Final Environmental Impact Report

Z-Best Composting Facility Modifications

April 24, 2024

Figure 1: Conceptual Intersection Layout for Alternative 3 + Cumulative Scenario (not to scale)

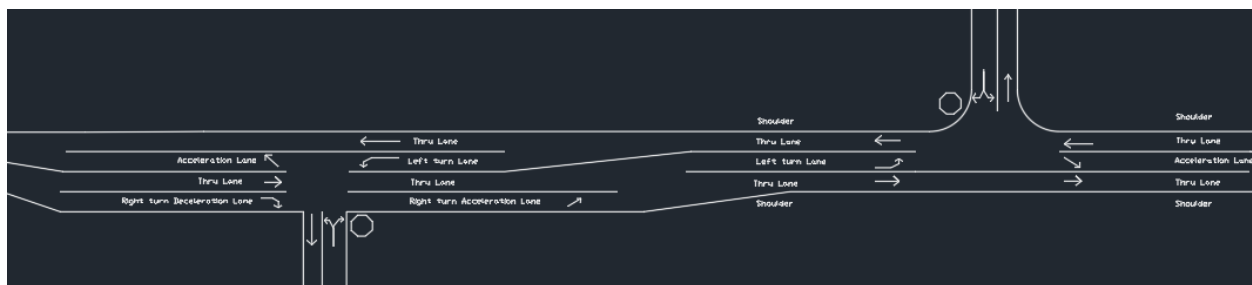
Caltrans has documented operational benefits of a SB receiving lane from Bolsa Road and documented these benefits with the project sponsor in an Intersection Control Evaluation (ICE) report. Caltrans recommends that the project add a receiving lane in the SB median for traffic making a left from SB Bolsa Road onto SB SR-25. It should be noted that the proposed project uses all available Right-of-Way (ROW) making it a challenge for Caltrans to pursue the addition of a receiving lane as a standalone project. As stated previously, and as a condition of approval for any Caltrans encroachment permit, Caltrans requests that the appropriate ROW considerations are made as to not preclude future intersection improvements.

To adequately evaluate the potential impact of the truck turning patterns on SR-25, please provide more information, such as truck turning radius and center turning radius, for Caltrans to review.

Truck turning radii for the proposed intersection layout are provided in Figure 4 of Appendix G-1 to the RDEIR; however, the proposed intersection layout shown in that figure would not be implemented, due to the requirements of mitigation measure MM-TRA-2 (which requires either signalization of the intersection or retention of the existing driveway location with additional improvements). Details of the mitigated driveway layout, including truck turning radii, would be provided by the Applicant to Caltrans for review and approval as part of the encroachment permit process.

Updated Figure 15-2 Conceptual Intersection Layout for Proposed Project and Project + Cumulative Scenarios

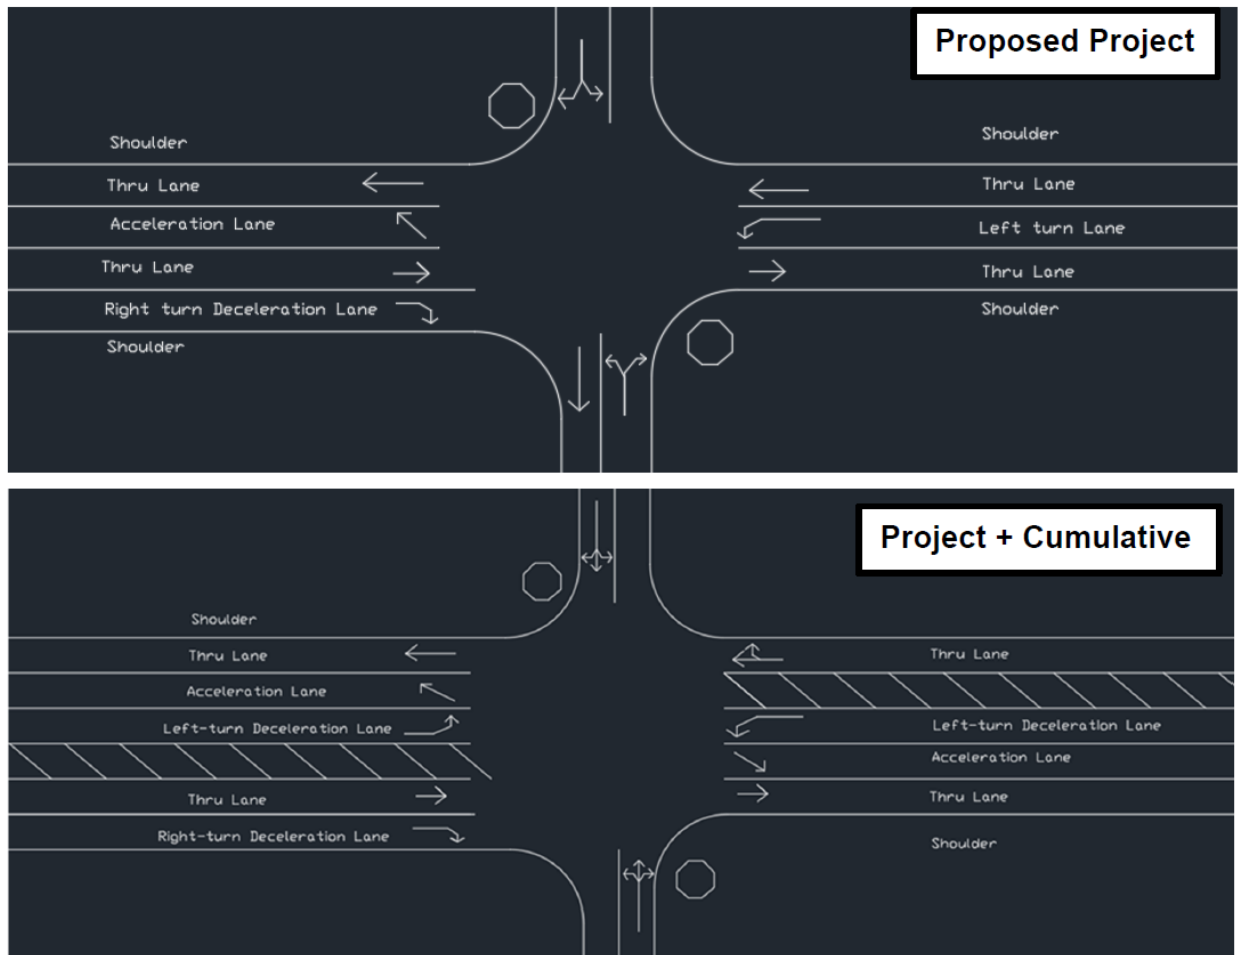
In Section 15.3.11.3 of the RDEIR, Figure 15-2 has been replaced as a staff-initiated change, as a formatting issue within the RDEIR resulted in the lower half of the figure not displaying correctly. A copy of the updated figure is included in Appendix C of this document.
